STUDER

Service Information

Appendix to A820 MCH
Service Manual 10.27.0662

SI 115/88 E

Fig. 1

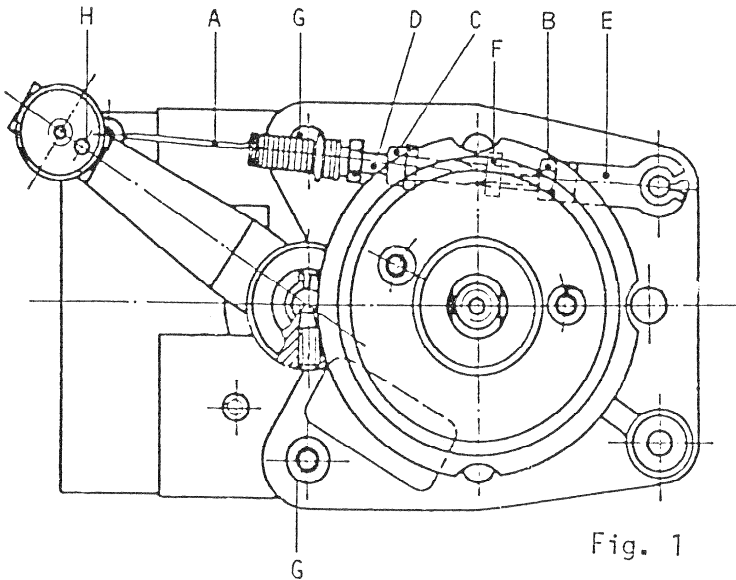
- Remove existing spring
- Install new spring and turn 3 spring-coils into the threaded pin (D).
- Adjust for a distance of 2mm between nut (B) and (F), by loosening locknut (B) and turning threaded pin into the counter piece (E). Fig. 1.

Fig. 3

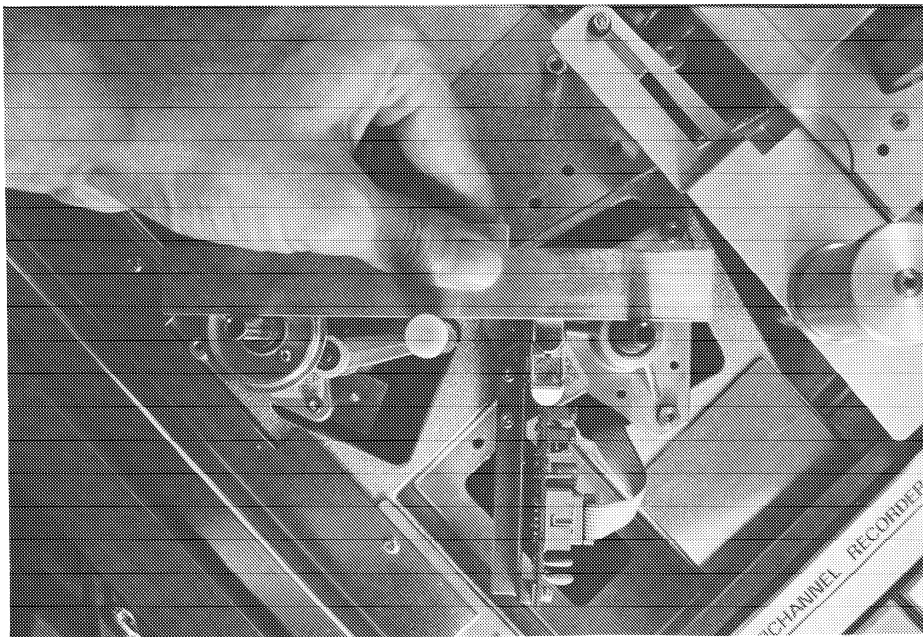
- Remove guide roller and prestabilizer roller (left) or tacho roller (right), respectively.
- Connect digital voltmeter to the two test points TP1 ("+") and TP2 (ground).
- Insert gauge (10.010.001.34) for adjusting the tape tension sensors according to Fig. 3, adjust with R7 (Offset-Adjust) to a voltage of 0.400 V +/- 20mV.
- Insert gauge (10.010.001.34) for adjusting the tape tension sensors according to Fig. 4, adjust with R9 (Gain-Adjust) to a voltage of 2.400 V +/- 50mV.
- Recheck the adjustment alternatively and realign if necessary.

Fig. 5

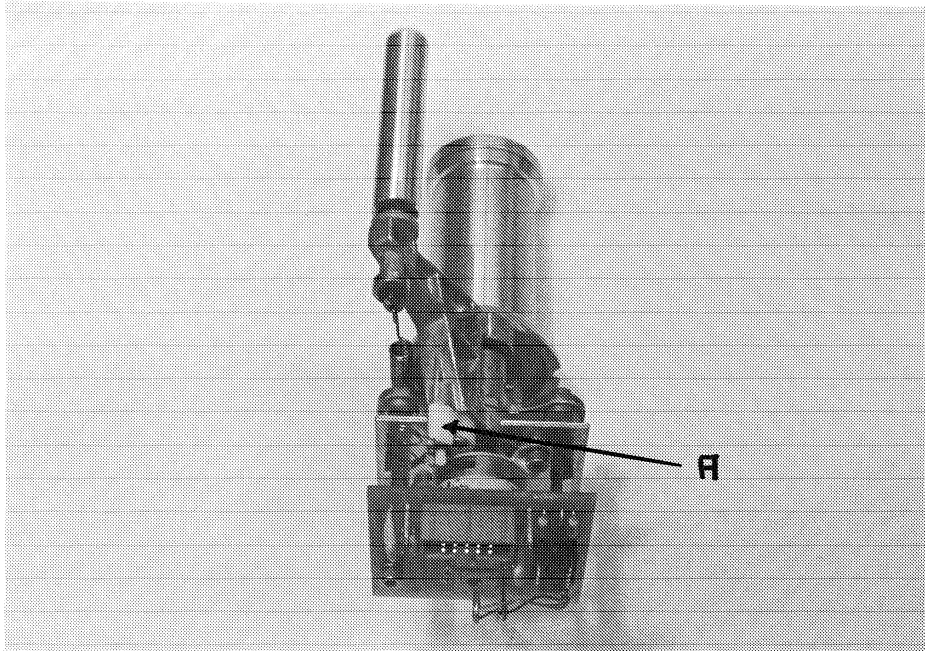
- Loosen screws (G) and reposition the mechanics.
- Check voltage in neutral position again.
- If the desired voltage is not adjustable by repositioning the end stop, then the white plastic driver piece (A) needs to be adjusted Fig. 5.
- Check voltage in neutral position again.
- Recheck the adjustments of R7 and R9 again.

Fig. 6

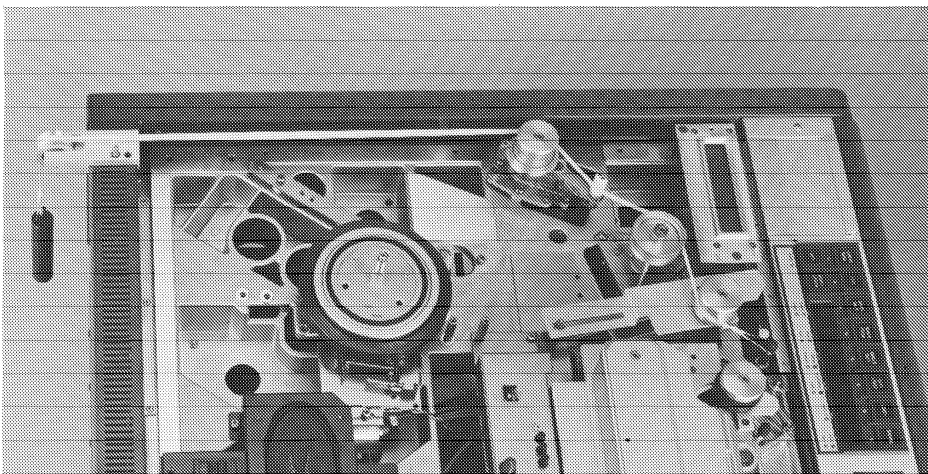
- Install guide and prestabilizer/tacho rollers.
- Install adjusting device (part No 10.010.001.31 also used for A820 1/4", 1/2") on the tape transport according to Fig. 6.
- Connect digital voltmeter to the two testpoints.
- Loosen locknut (B) of threaded pin (C).
- Hook on small weight 120g for 2" (10.010.001.35), 75g for 1" (10.010.001.36)
- * Adjust the voltage to 200mV +/- 30mV by turning the threaded pin (C) (voltage increases when turning out the threaded pin).
- * Tighten the locknut (B), the voltage must remain between the indicated limits.
- * Hook on the large weight 520g for 2" (10.010.001.35), 325g for 1" (10.010.001.36)
- * Adjust the voltage 2.2V +/- 50mV by turning the adjusting pin (D) (voltage rises when the spring is elongated)

Fig. 14

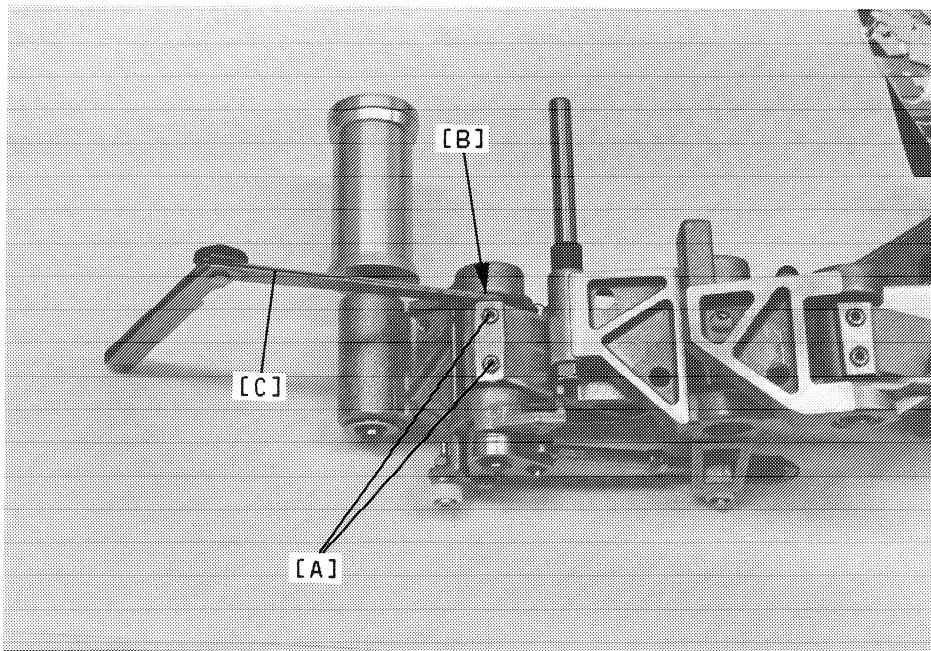
- Remove the tape drive-assembly. Loosen the set screws A (Fig. 14) and adjust to a distance B for 1,6 mm by using a feeler gauge C (Fig. 14). Reinstall the assembly.

Fig. 15

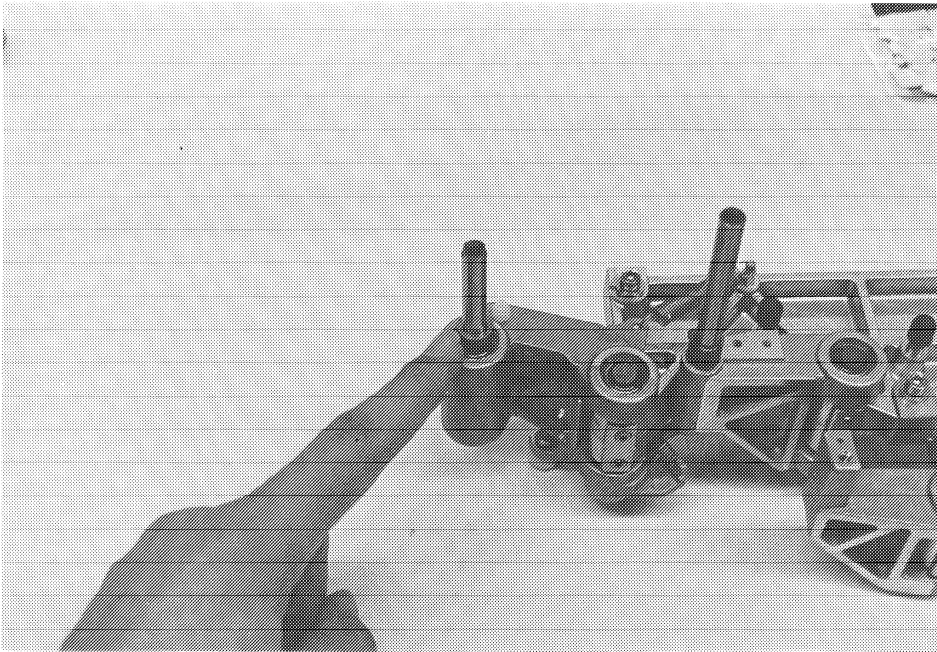
- Check roller height as per chapter 6.1 Step 3. In most cases the rollers will be positioned too low which is actually desirable. By fitting or removing spacer discs, the correct roller height must now be determined. Install spacer discs firstly directly underneath the rollers as Fig. 15 shows (experimental stage), once the correct height is determined install the spacer discs in the position Fig. 16 shows i.e between shaft and top ballbearing.
